Claridge Developments Proposed High-Rise Residential and Care Facility 1705 Carling Avenue City of Ottawa

Servicing and Stormwater Management Report

Reference: 1705 Carling Avenue
1st Review - Response to Engineering Comments
City File No.: D07-12-20-0048
Our File No.: 120010

LOCATION 1705 CARLING AVE, CITY OF OTTAWA PROPOSED HIGH-RISE RESIDENTIAL AND CARE FACILITY	PROJECT No. 120010-00
DRAWING NAME GENERAL PLAN OF SERVICES	REV # 3
DRAWING No. 120010-GP

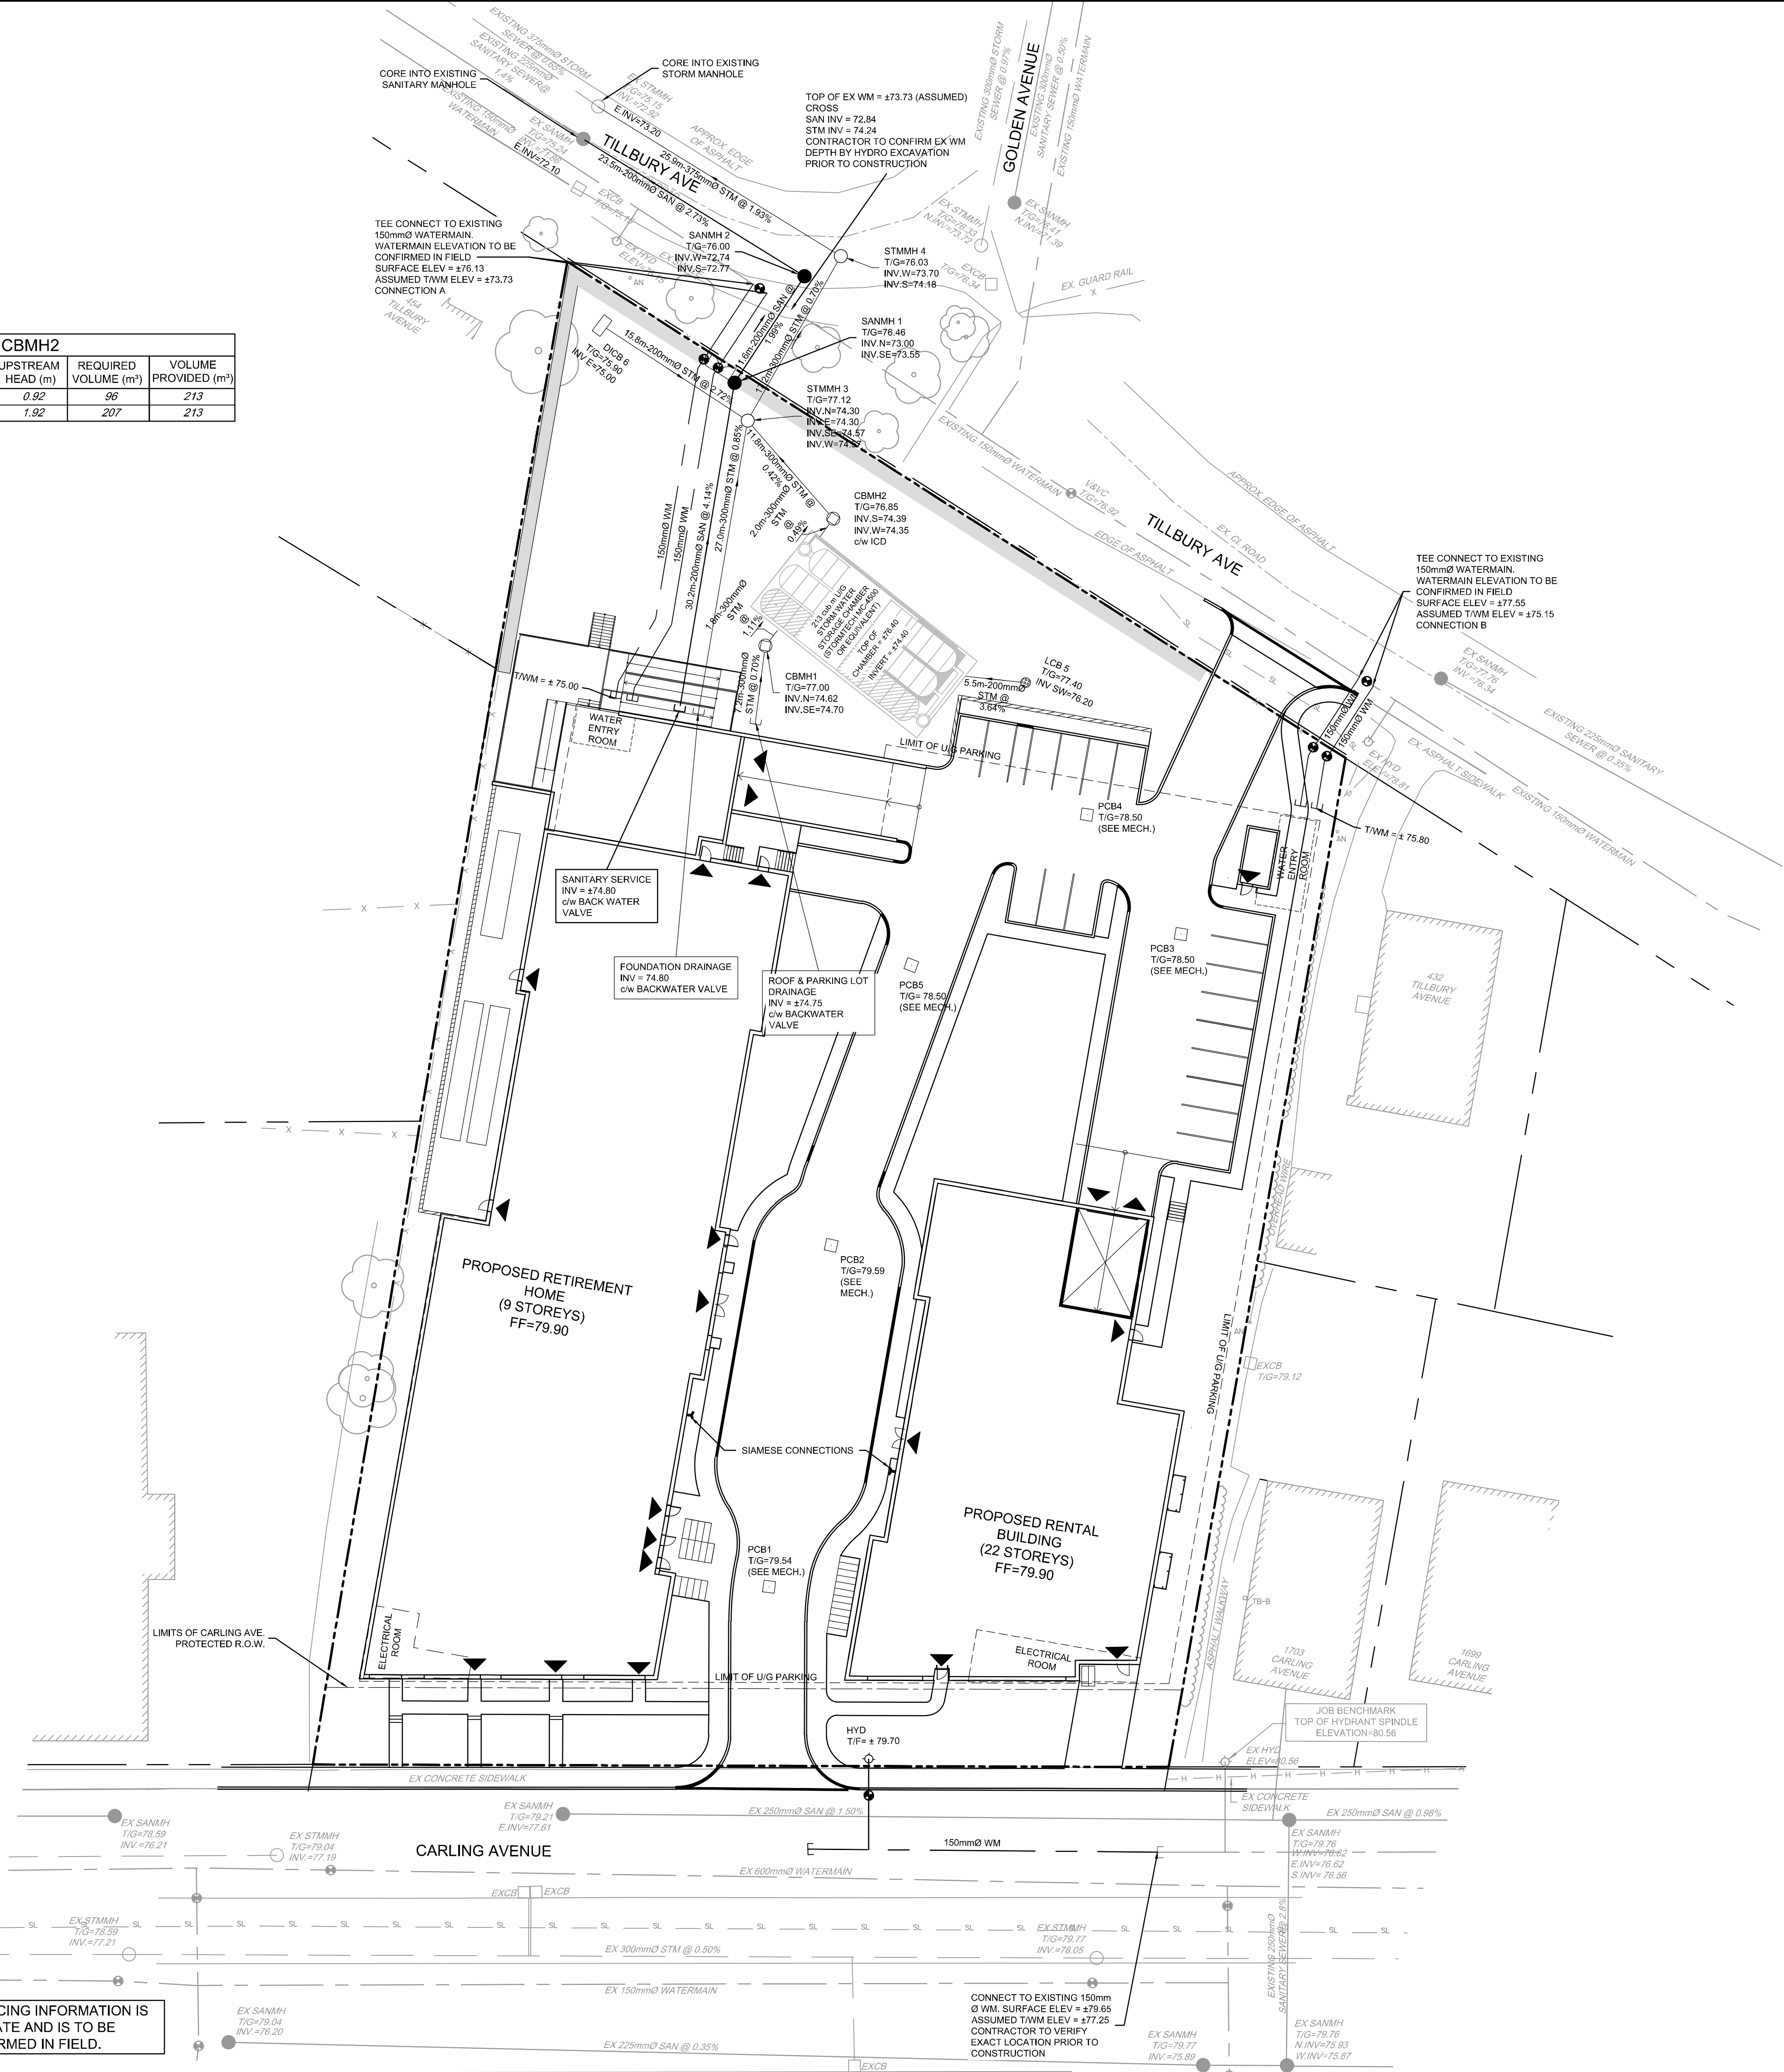
63. Show Back Water Valves (BWV) on drawing for foundation drain.

67. Provide location, type and flow rate for ICD at Storm Chamber on Site Servicing Drawing

Novatech Response: A back water valve has been indicated on the foundation drain label.

Novatech Response: The ICD is in CBMH2 and has been labelled. For ICD details, refer to the "Inlet Control Device Data – CBMH2" table on the General Plan of Services.
